AGENCY REVIEW & APPROVAL FORM
Information on this form must be filled out and signed by approving agency.

Job Site Address: 38506 HWY 30 City: ASTORIA
Owner: BILL HEROLD Phone: _____
Address: 38506 HWY 30 Email: DONPACHAL@GMAIL.COM
Agent: EABLE CONSTRUCTION / DON PACHAL / 503-440-1573
Proposed Development/Construction: BUILD GARAGE & ADD BATHROOM IN HOUSE
(3 Bdrms)

HEROLD HOUSE
 38506 Hwy. 30
 Astoria OR 97103

4. FIRE DEPARTMENT/FIRE DISTRICT ACCESS AND WATER SUPPLY REQUIREMENTS:

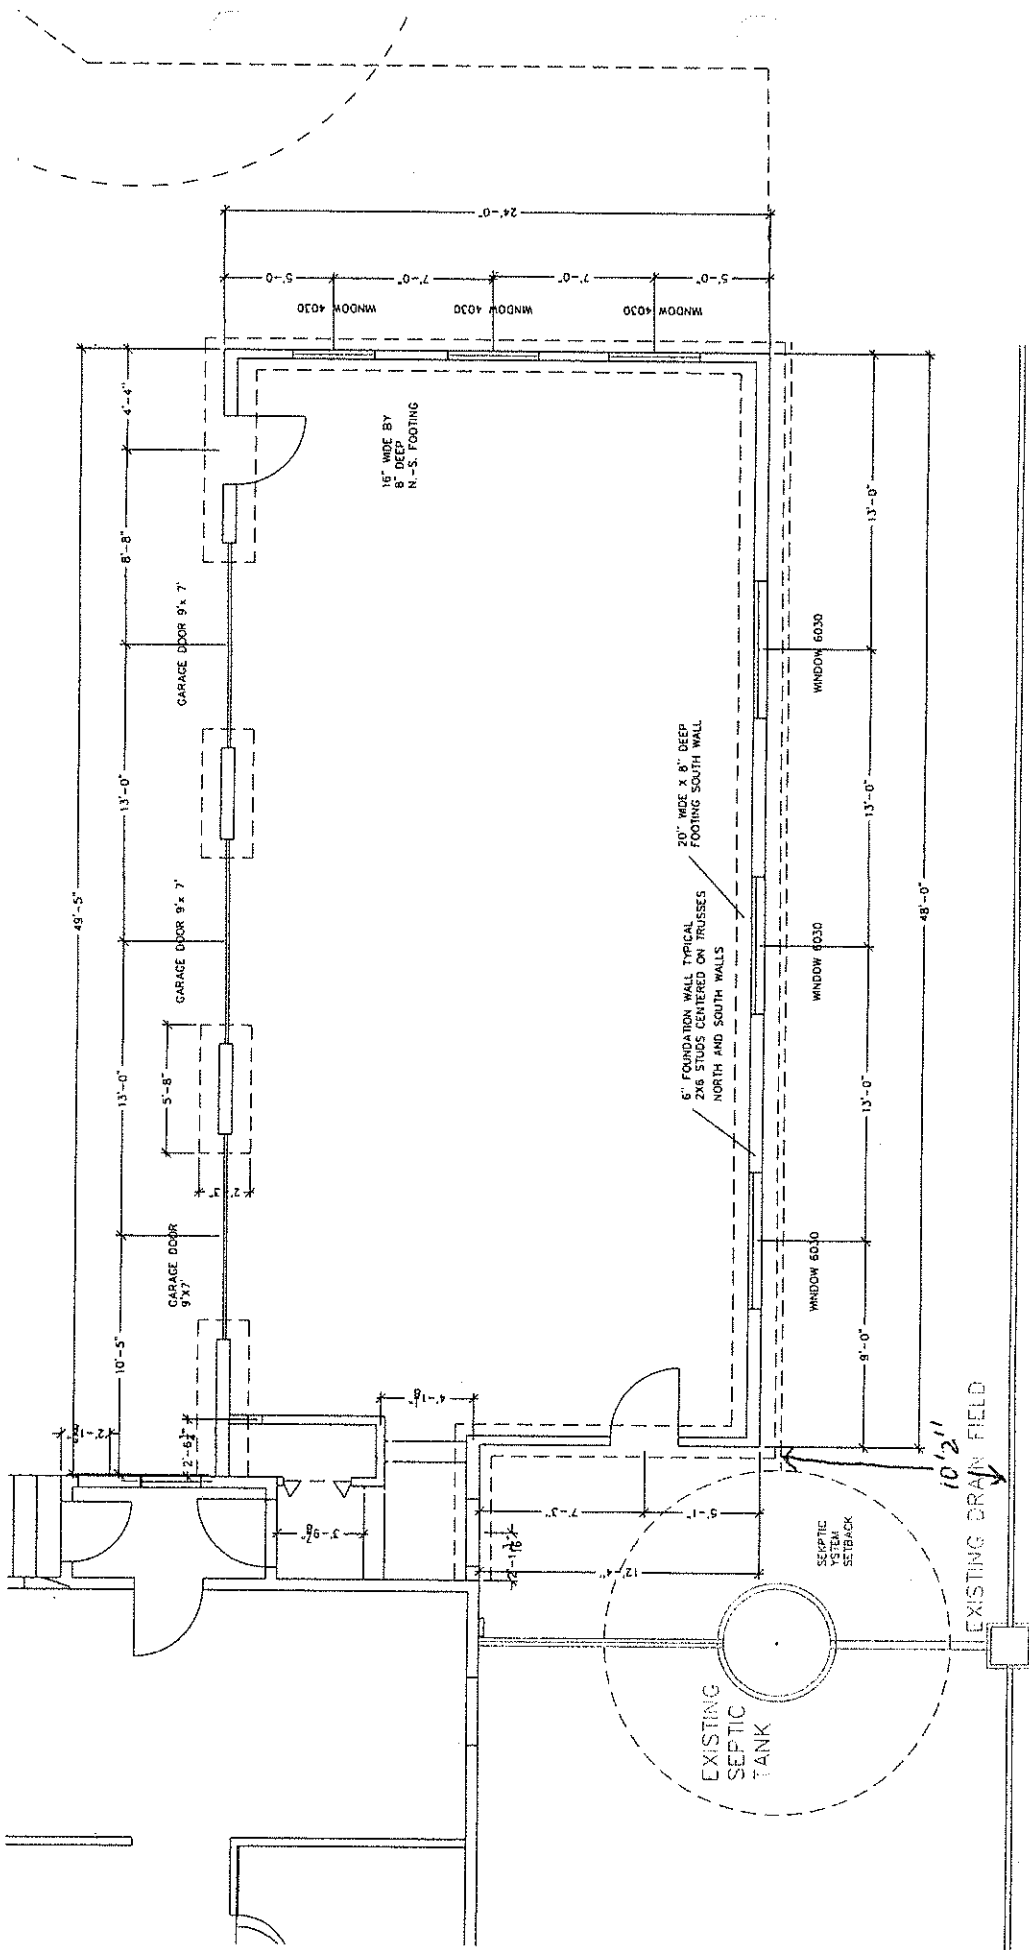
Water/Fire Flow: N/A Number of Hydrants: N/A Hydrant Location(s): N/A
Agency Signature: [Signature] Title: Chief Date: 12-11-18
Remarks: Existing Home site - Meets NFPA 1142 Requirements
